Proposal for Supplement 1 to the 04 Series of Amendments to UN Regulation No. 127 (Pedestrian safety)

Submitted by the experts from France, Germany, Netherlands, Japan, and the International Organization of Motor Vehicle Manufacturers *

Figure 12
Windscreen test area

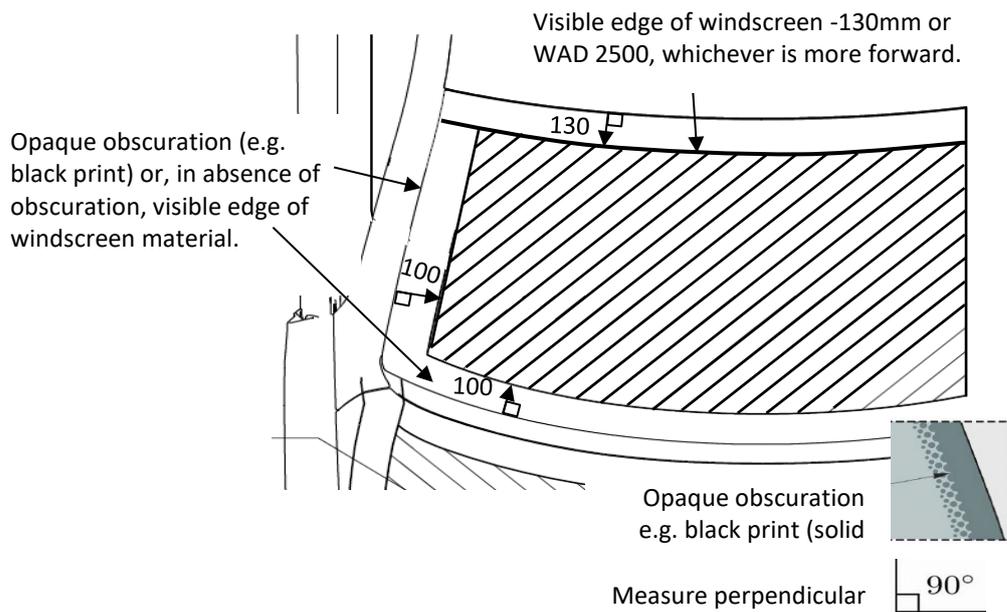
Paragraph 2.44., amend to read and insert Figures 12 and 13:

"2.44. "Windscreen test area" is an area on the outer surface of the windscreen. It is bound (**see figure 12**):

- (a) In the front, by a line 100 mm rearward to the opaque obscuration of the windscreen. In case of absence of the opaque obscuration, the line is measured from the front visible edge of the windscreen material.
- (b) In the rear, by a WAD 2,500 or a line 130 mm forward to the rear visible edge of the windscreen material, whichever is more forward at a given lateral position.
- (c) At each side, by a line 100 mm inside the opaque obscuration of the windscreen. In case of absence of the opaque obscuration, the line is measured from the side visible edge of the windscreen material.

For (a) and (c): the distances of 100 mm are to be measured with a flexible tape held tautly along the outer surface of the vehicle at an angle of 90° to the tangent line to the opaque obscuration limit or in case of absence of the opaque obscuration, from the visible edge respectively.

For (b): the distances of 130 mm is to be measured with a flexible tape held tautly along the outer surface of the vehicle at an angle of 90 ° to the tangent line to the rear visible edge of the windscreen.

Figure 13
Upper corner definition with "shortest distance"

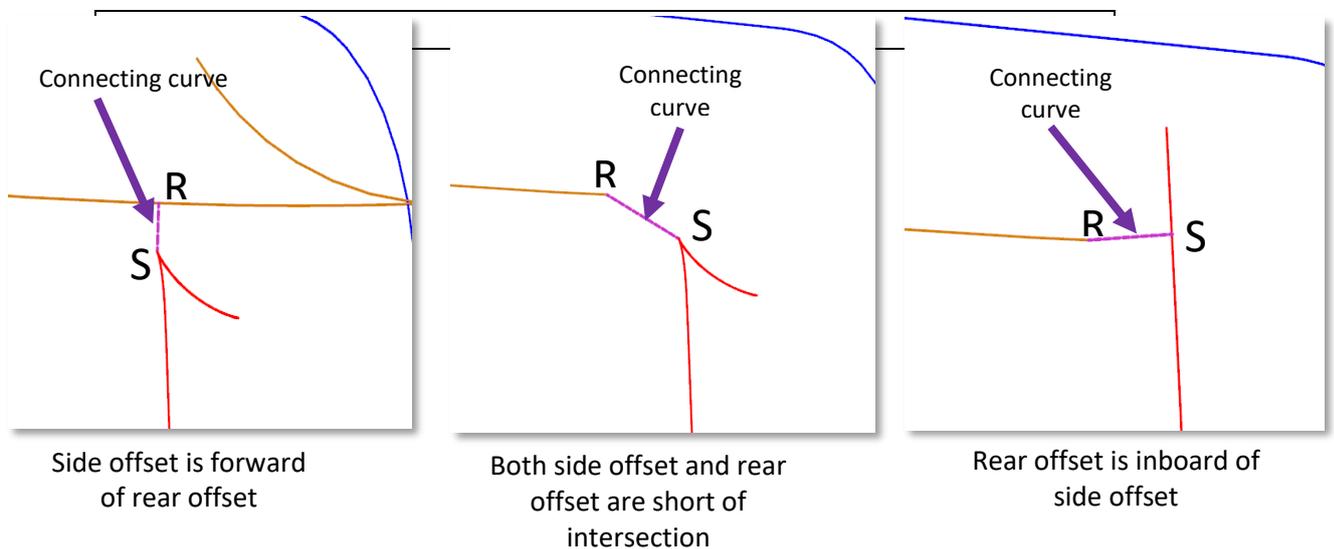
Depending on the geometry, in case there is no intersection between (b) and (c), resulting in an open test area, then the marking shall be modified using the shortest distance to close the open test area (see figure 13).

Particular case, if no unique "P point" corner

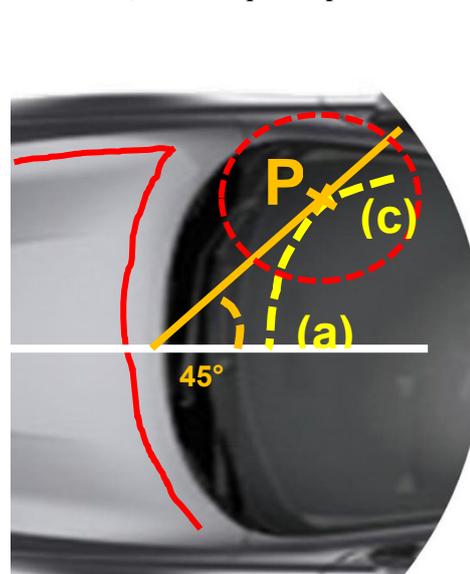
If there is no unique "P point" where the lines defined in 2.44 (a) and (c) intersect, then the "P point" is defined by the first contact of a vertical plane intersecting the vertical longitudinal vehicle center-plane at an angle of 45° with the (a)-(c) transition of the windscreen test area boundary, as shown in Figure 15.

Figure 16
Jerk criterion graph and formula

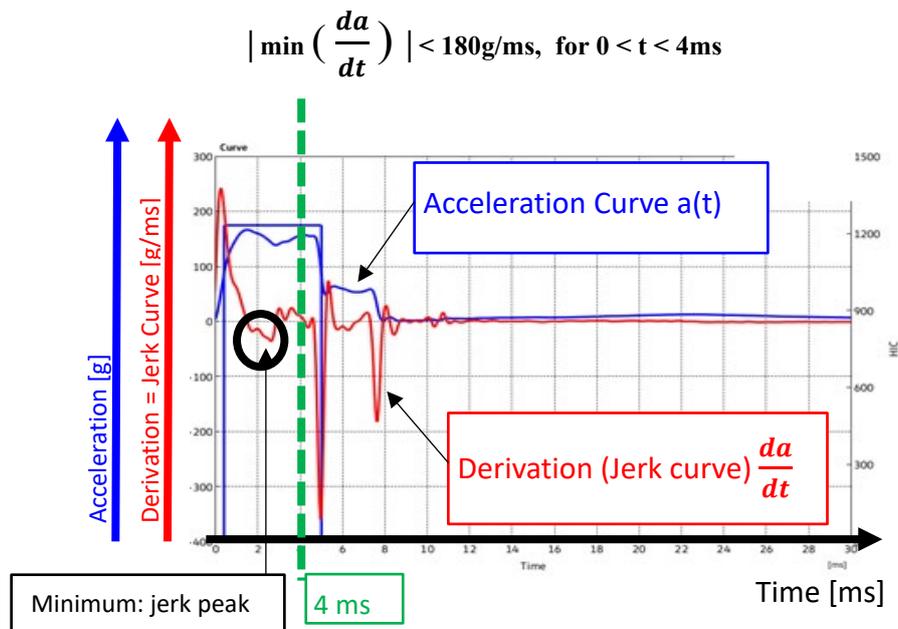
- (a) The absolute value of the minimum value of the derivation of the headform acceleration versus time is ~~below~~ **less than 180 g/ms** ~~for~~ **within** the first 4 ms after the initial contact of the headform to the windscreen, **as shown in Figure 16**; or
